Type II Site Plan and Environmental Review Staff Report and Decision

Project Name: ACERO PADDED APARTMENTS

Case Number: PSR-2019-00013

Request: The applicant is requesting Site Plan Review approval for the construction of a 288 unit apartment complex, including accessory parking and open space areas, a property management and fitness center building, a pool, and a maintenance building. The site is located on approximately 13.78 acres in the office residential (OR-22) zoning district.

PRELIMINARY SITE PLAN

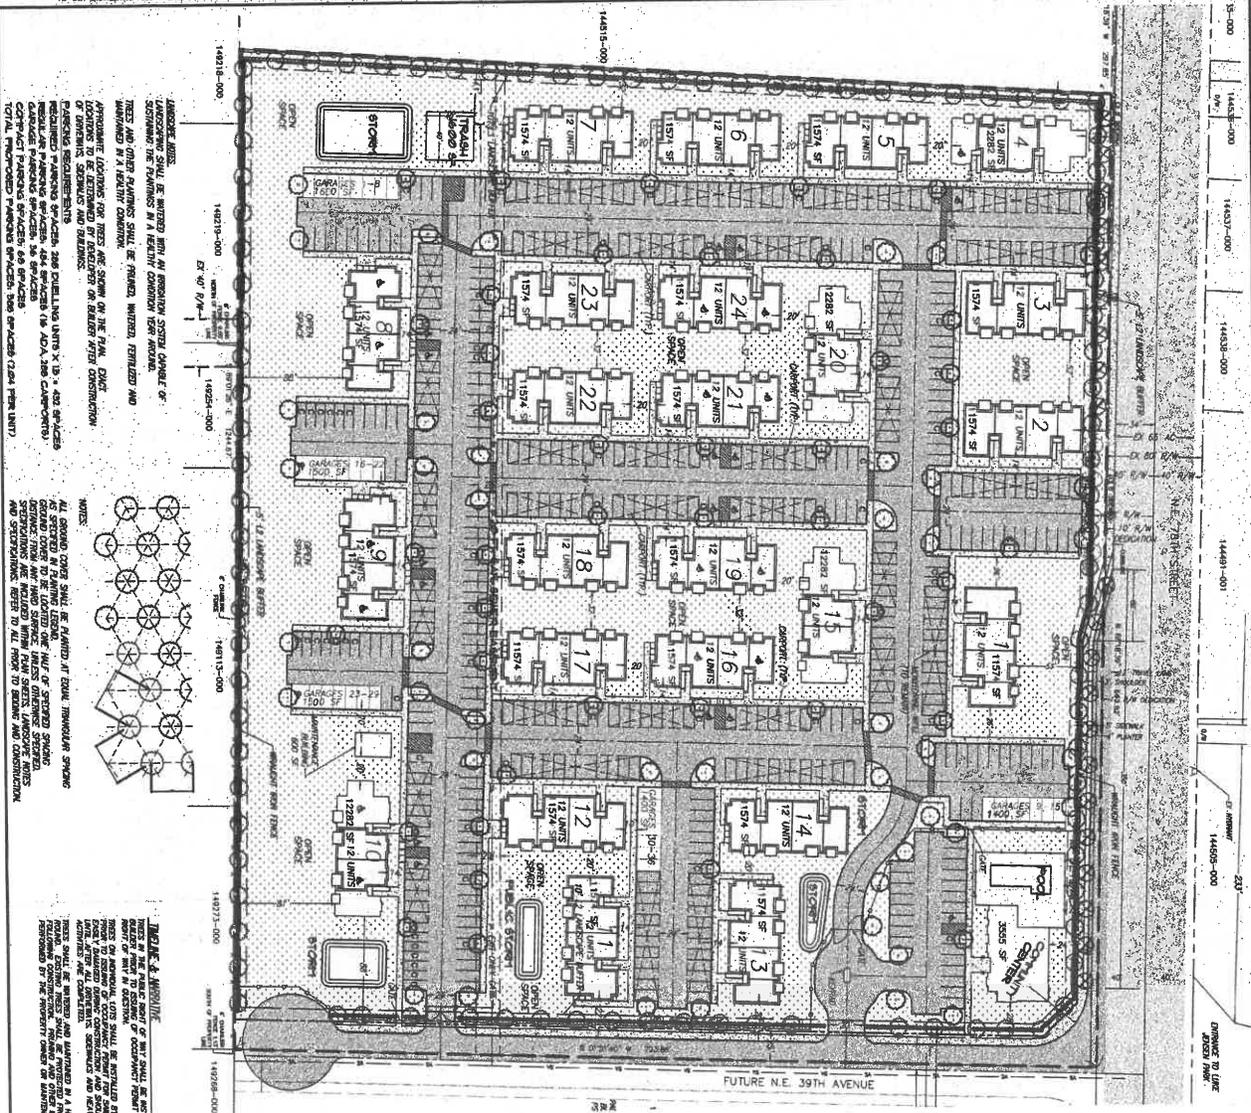
One landscape island with a tree for each 7 spaces must be provided per Section 40.320.010.E. The preliminary site plan shows islands meeting this requirement.

All landscape buffers indicated on the preliminary landscape plan conform to the above requirements. A final landscape plan will be required with the final site plan. (*See Conditions A-14 and F-1*)

The site plan shows 590 parking spaces, (including 471 regular, 66 compact, 36 garage, and 18 ADA spaces).

The traffic study indicates that the proposed development will construct the southern leg of the intersection of NE 39th Avenue/NE 78th Street. The applicant's plan shows that NE 39th Avenue will be extended south, from NE 78th Street, along the subject property frontage. NE 39th Avenue will terminate in a temporary cul-de-sac.

The applicant’s plan shows the construction of a 350-foot long right turn lane at the proposed intersection of NE 78th Street/NE 39th Avenue. The applicant has submitted a narrative that indicates that the right turn lane is being provided to remove the right turning vehicles from the eastbound mainline traffic.

The applicant will need to submit construction drawings that show the construction of a dedicated eastbound right turn lane that complies with the county standard details. (*See Condition A-8.b*)

- b. The applicant shall submit a signing and striping plan for review and approval. This plan shall show the construction of an eastbound right-turn lane on NE 78^h Street at NE 39th Avenue. This right-turn lane shall be designed in compliance with county
